# GTN XPress Project

## FINAL ENVIRONMENTAL IMPACT STATEMENT

Gas Transmission Northwest LLC

Docket No. CP22-2-000

Figure 2.1-2 GTN Xpress Project Area – Washington

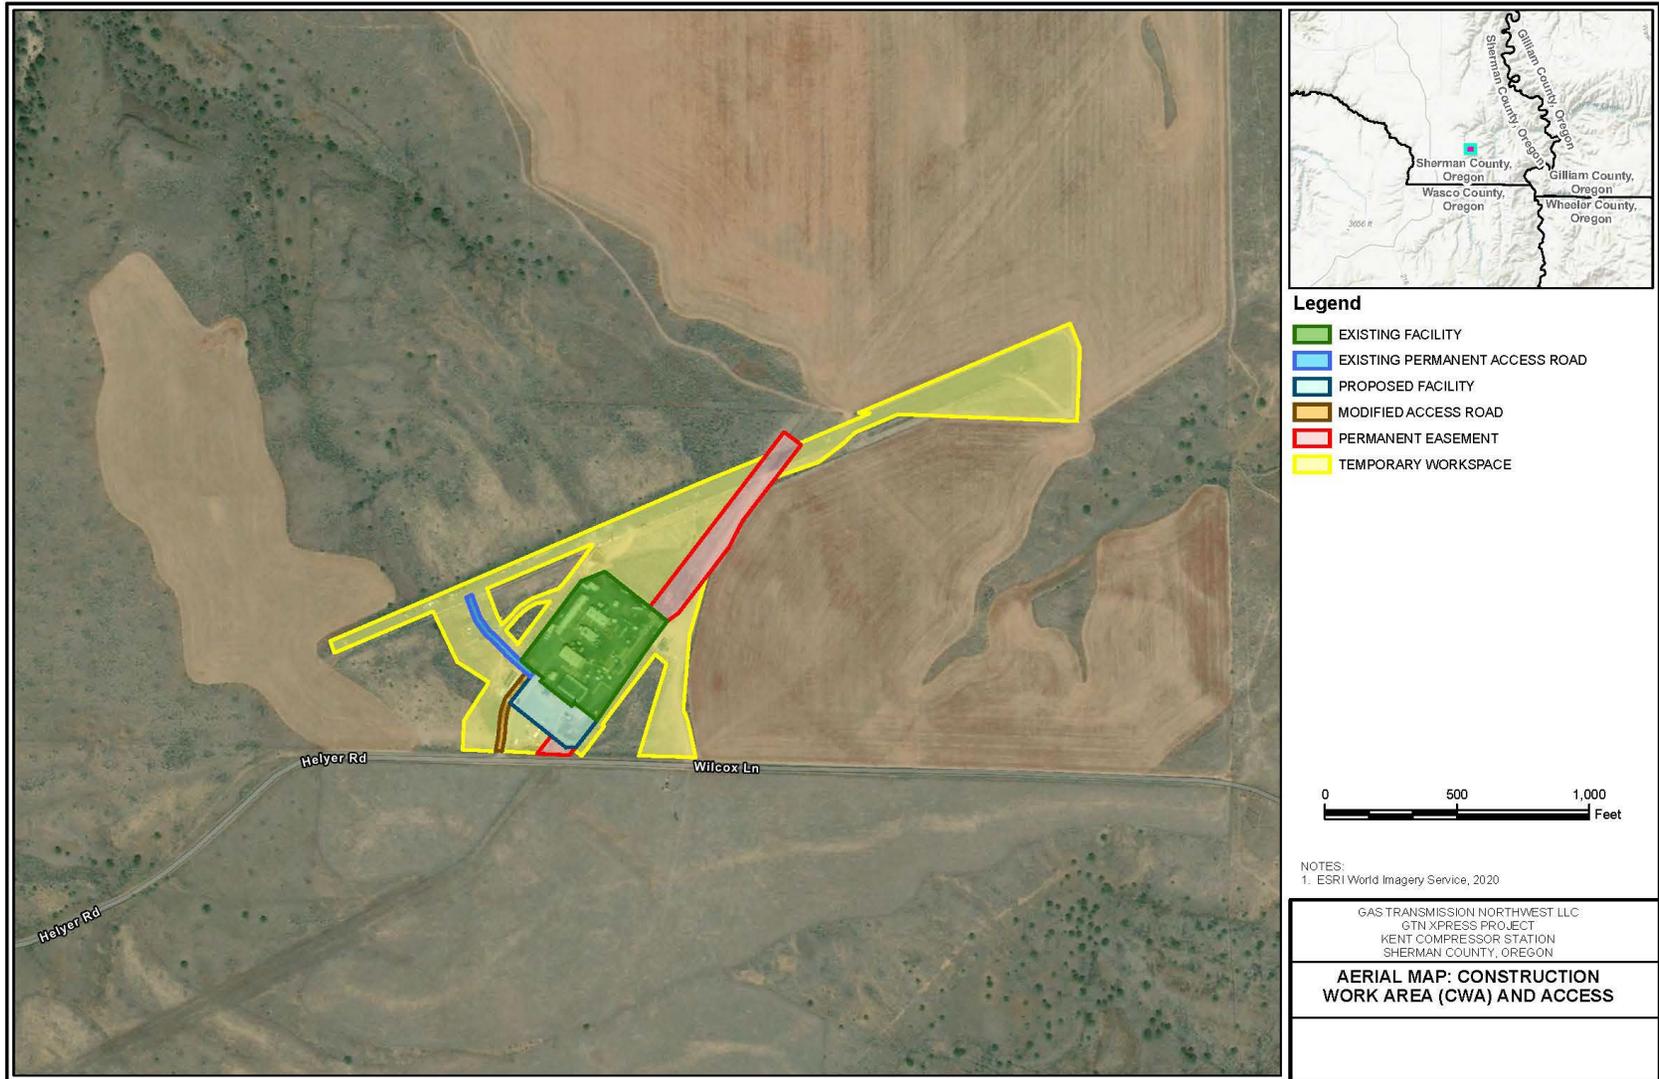
<sup>12</sup> DEIS 2-4. Note that this image is labeled in the DEIS as “Figure 2.1-2 GTN Xpress Project Area – Washington.” However, this appears to be the aerial map of the Kent Compressor Station in Sherman County, Oregon.

Figure 2.1-3 GTN Xpress Project Area – Oregon

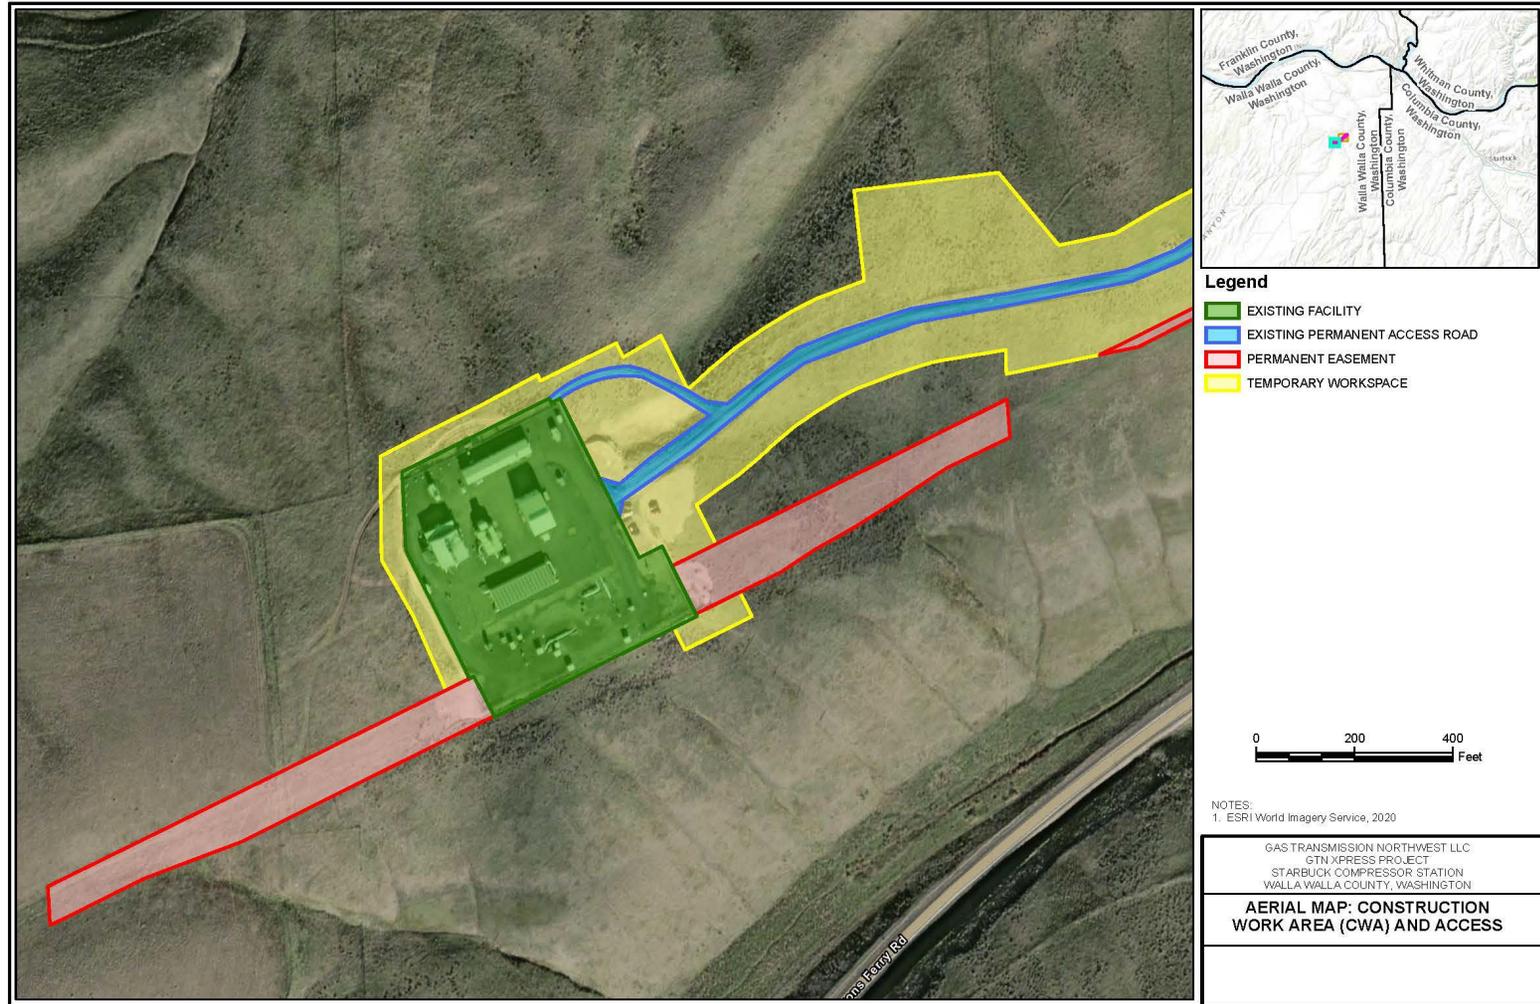
<sup>6</sup> DEIS 2-5. Note that this image is labeled in the DEIS as “Figure 2.1-3 GTN Xpress Project Area – Oregon.” However, this appears to be an aerial map of the Starbuck Compressor Station in Walla Walla County, Washington.
